APPENDIX E

AGENCY AND PUBLIC COMMENTS ON DRAFT P2TP/ RESPONSE TO COMMENTS

US Fish and Wildlife Technical Comments
Lake Okeechobee Watershed Construction Project
Phase II Technical Plan (Plan)

**Northern Everglades Initiative
Phase II Technical Plan - Draft Report Comments
SFWMD Comment Period Ending 13-Dec-07**

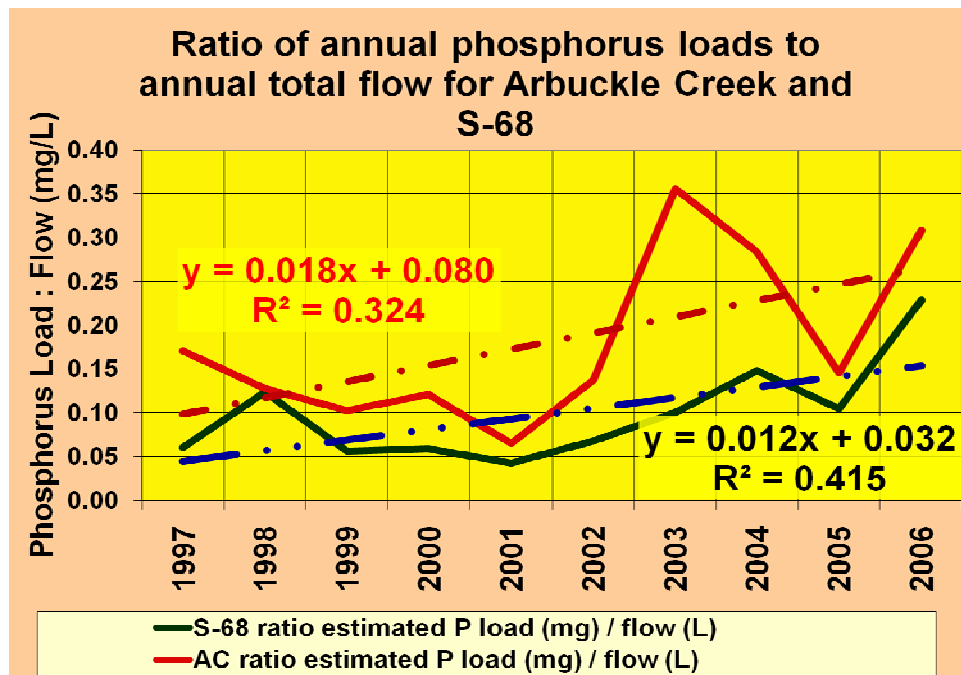
- A trend analysis of P dynamics in Lake's Istokpoga and Kissimmee should be conducted. P control measures from these lakes are based on average loads over the past 15 years, but we note that P concentrations have roughly doubled from these lakes over this time period (Fig. 1 shows recent Istokpoga trends). If the increasing trend continues, calculations based on the present average will underestimate future needs.

A - 12

- 5-13 The same concerns discussed for changing P levels and future saturation on the Kissimmee Chain and River apply to Istokpoga (Fig. 1). Planning to use these lakes to treat P in the short term will cause more severe, and expensive, P problems in the long term. The Plan must explicitly develop strategies to prevent P saturation. A - 28

Comment No.	Response
	would be implemented in the Lake Istokpoga watershed to address increasing nutrient levels. These source control efforts are underway but have not been fully implemented and therefore current data does not reflect improvements that are anticipated with full bmp implementation. BMP effectiveness and the need for regional projects will continue to be evaluated through the Plan update process and if necessary, adjustments can be made in later versions of the Plan.
A-29	No response required
A-30	Figures 5-11 and 5-12 were used during alternative plan formulation to identify “hot spot” sub-watersheds that were targeted for potential implementation of phosphorus reduction measures. Those sub-watersheds that were plotted in the figures above the diagonal line contributed disproportionately large phosphorus loads to Lake Okeechobee relative to their flow volumes. Even though the Upper and Lower Kissimmee Sub-watersheds contribute large phosphorus loads, phosphorus concentrations are low because these sub-watersheds contribute the largest volumes of flow to the lake. Phosphorus reduction is generally more difficult and expensive for water bodies with low concentrations. Therefore, since the Fisheating Creek, Taylor Creek/Nubbin Slough, and Indian Prairie Sub-watersheds had relatively high phosphorus concentrations, they were investigated more closely as potential sites for implementation of phosphorus reduction measures. If the Y-axis scale was changed to metric tons, the figures would no longer serve the purpose for which they were used.

page 9-18 Section 9.2.3.3 line 607

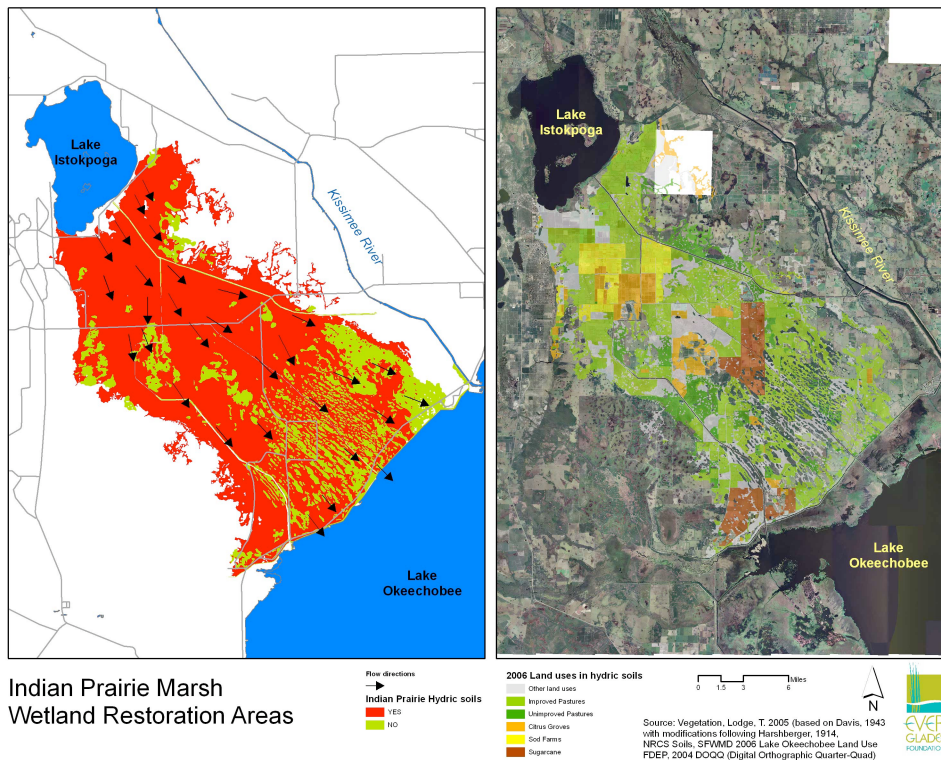
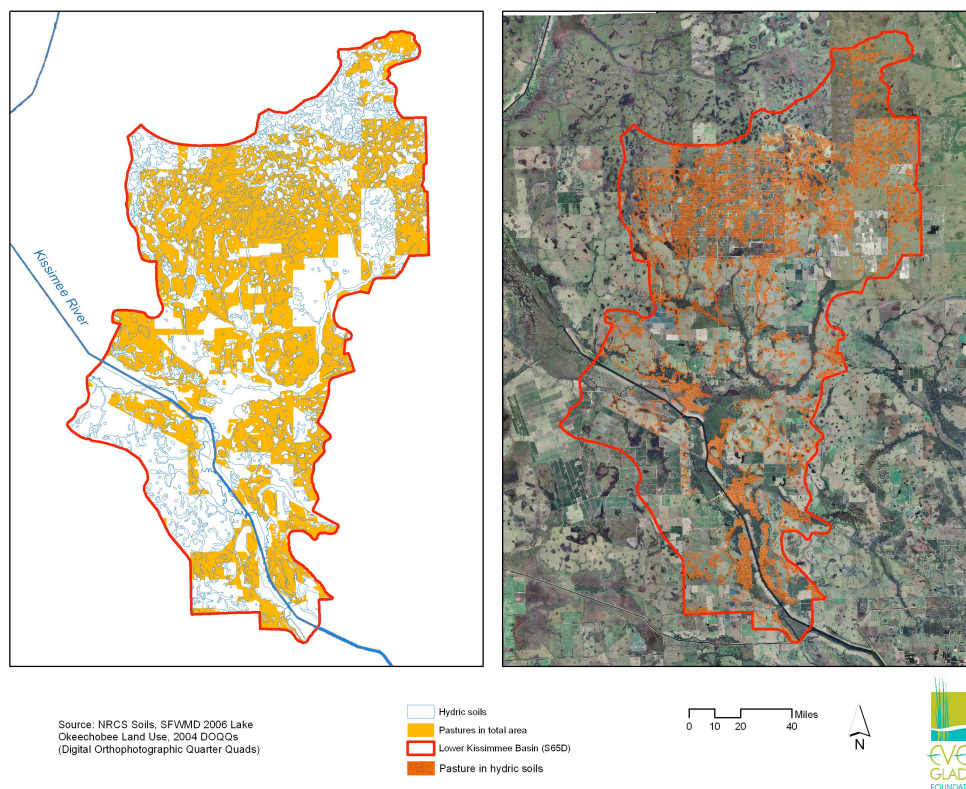
We are extremely pleased to see that Wetland Restoration is included in this plan. This will be an important step in improving the overall ecological function of the basin, rather than sacrificing the basin for the sole benefit of other areas. However, we would like to see an identification of other areas that could greatly improve overall basin ecological function. We suggest that the S-65D basin and the Lake Istokpoga basin are good candidates for restoration, as shown in the figures below.

Expansion of viable wetlands in the Indian Prairie marsh would greatly improve the ecological function of the basin and the Lake.

S-65D also has significant possibilities for wetland restoration, improving storage and ecological function.
